**Re: Transportation Study Addendum
 117 Forest Avenue and 175 Catharine Street South
 City of Hamilton
 Our Project No. NT-16-103**

NexTrans Consulting Engineers (A Division of NextEng Consulting Group Inc.) was retained by Representative Holdings Inc. (The Client) to undertake a Transportation Study Addendum to address the City's comments for the proposed Zoning By-law Amendment application and site plan application. The subject sites are located at municipal addresses 117 Forest Avenue and 175 Catharine Street South, in the City of Hamilton.

Figure 1 – Proposed Daylight Triangle at Catharine Street S/Forest Avenue

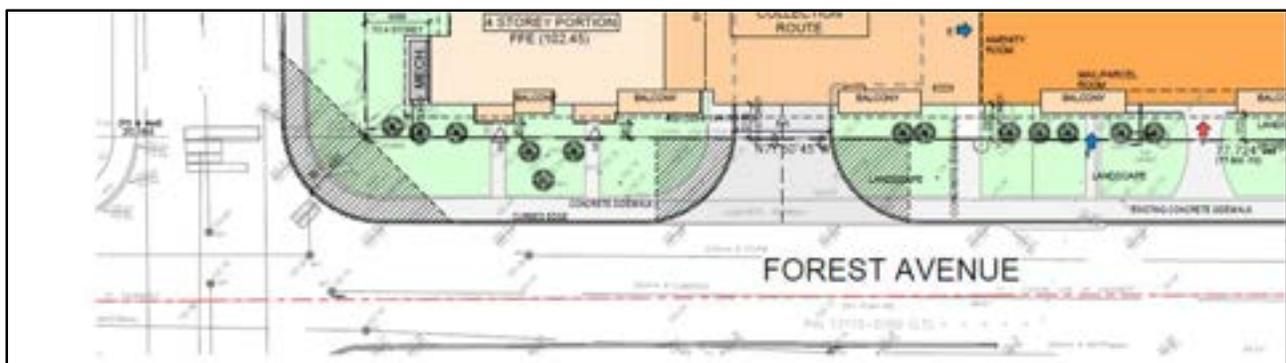
6. Catharine Street South & Forest Avenue are both Local Roads. The Applicant is to dedicate a 4.57 metres x 4.57 metres Daylighting Triangle to the right-of-way, as per the Council Approved Urban Official Plan: Chapter C - City Wide Systems and Designations 4.5 Road Network Functional Classification; Daylighting Triangles 4.5.7.

8. The required 4.57 metres x 4.57 metres Daylighting Triangle at the intersections of Catharine Street South & Forest Avenue, and Catharine Street South & Young Street have not been indicated or illustrated on the site plan. The site plan is to be revised in order to clearly indicated, illustrate and dimension the required 4.57 metres x 4.57 metres Daylighting Triangles accordingly.

Response: Noted. This requirement has been addressed in the revised site plan.

Response: Noted. This requirement has been addressed in the revised site plan.
